Amendment No. 2

Generation Interconnection Agreement

LCRA Transmission Services Corporation

FPL Energy Upton Wind II, LLC

Exhibit "C-2"
POINT OF INTERCONNECTION DIAGRAM

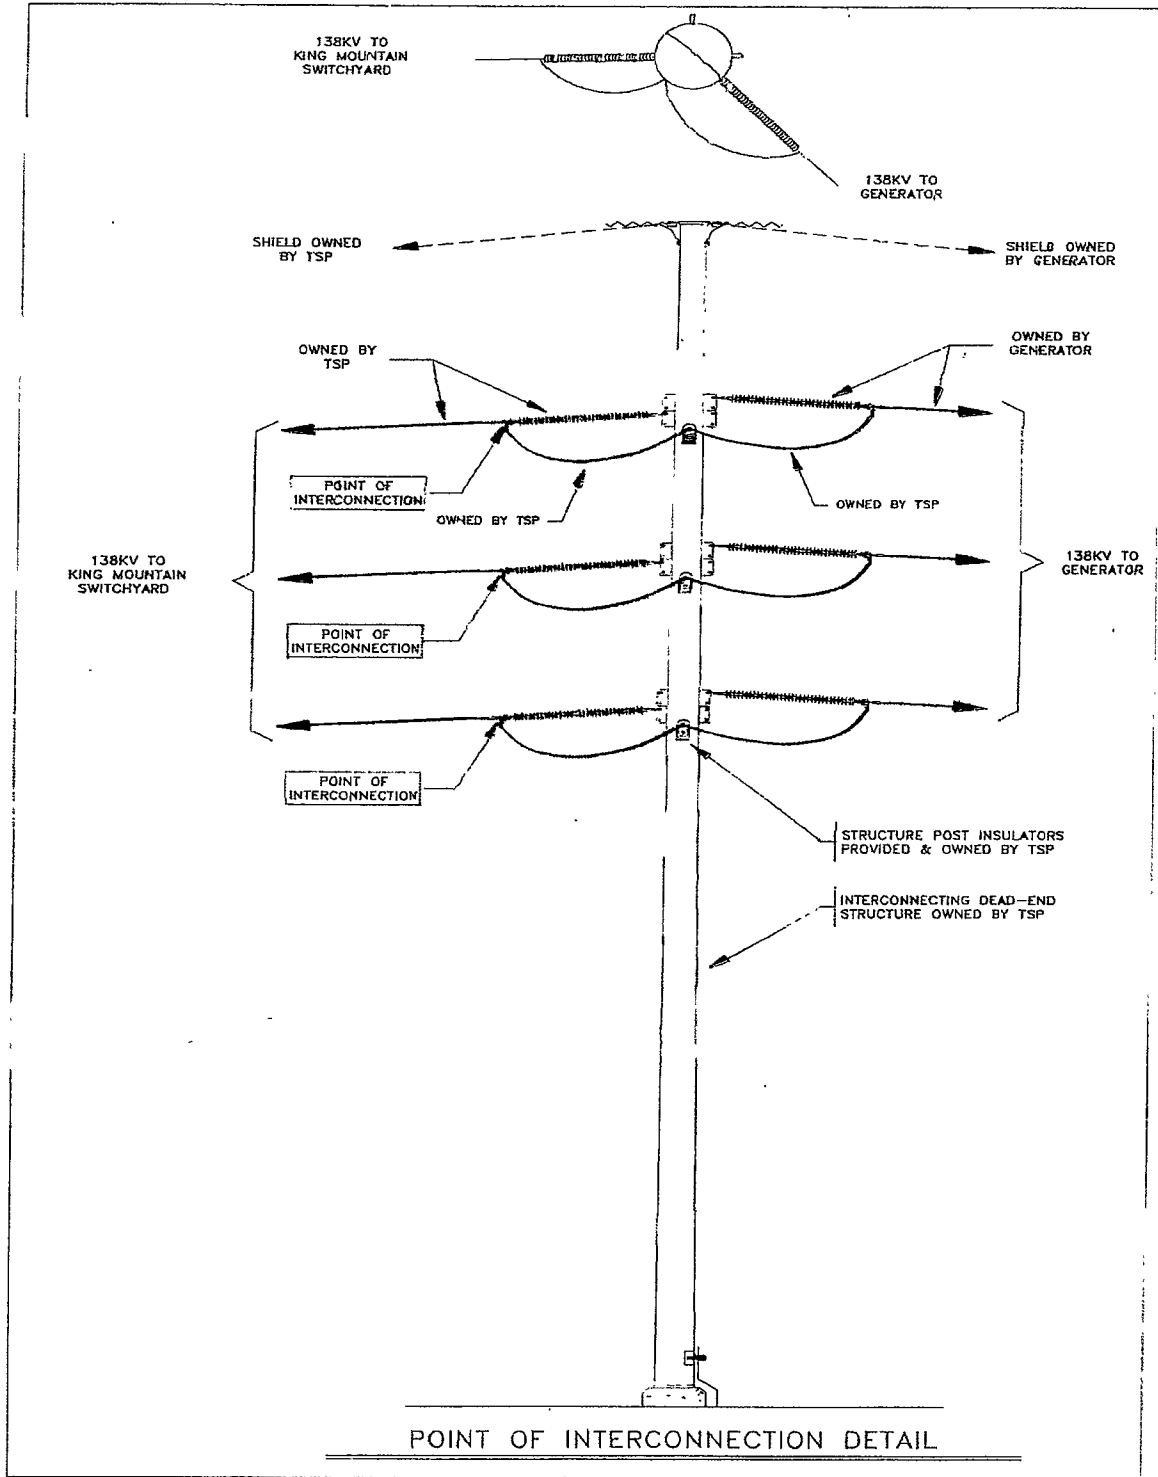
WHEREAS, this amendment to the Interconnection Agreement is necessary because the TSP will install 138-kV circuit breakers to increase transmission service reliability at the King Mountain Switchyard and the description of the LCRA TSC Transmission Interconnection Facilities (TIF) requires updating; and

WHEREAS, the ERCOT Polled Settlement metering will be relocated from the plant to the TSP's new switchyard at King Mountain Switchyard.

1. Exhibit "C" Interconnection Details (including the diagrams Exhibit "C-1" and "C-2" attached thereto), attached to the agreement, is deleted in its entirety and Exhibit "C" Interconnection Details (including the diagrams attached thereto), attached to this Second Amendment, is hereby added to the Agreement in lieu thereof.

A). TSP's ERCOT polled settlement ("EPS") metering will be located at the TSP Switchyard as part of the TIF. Three 138-kV extended range, metering current transformers will be used to accurately read the generation energy and power delivered to the grid and the auxiliary energy and power consumed through the Point of Interconnection. Three 138-kV metering accuracy voltage transformers will also be installed by the TSP for the ERCOT settlement metering. The ERCOT settlement metering panel furnished by the TSP will be located in the TSP Switchyard.

B). TSP will provide one ERCOT Polled Settlement (EPS) metering point at the TSP Switchyard to accommodate both Generator and FPL Energy Upton Wind I, LLC through a single Point of Interconnection. The single EPS meter located at the Point of Interconnection will measure all energy flows for the Plants. The allocation of the EPS meter data to each generating entity is the responsibility of the Generator and FPL Energy Upton Wind I, LLC and will be in accordance with Section 10.3.2.1 of the ERCOT Nodal Protocols, or its successor.
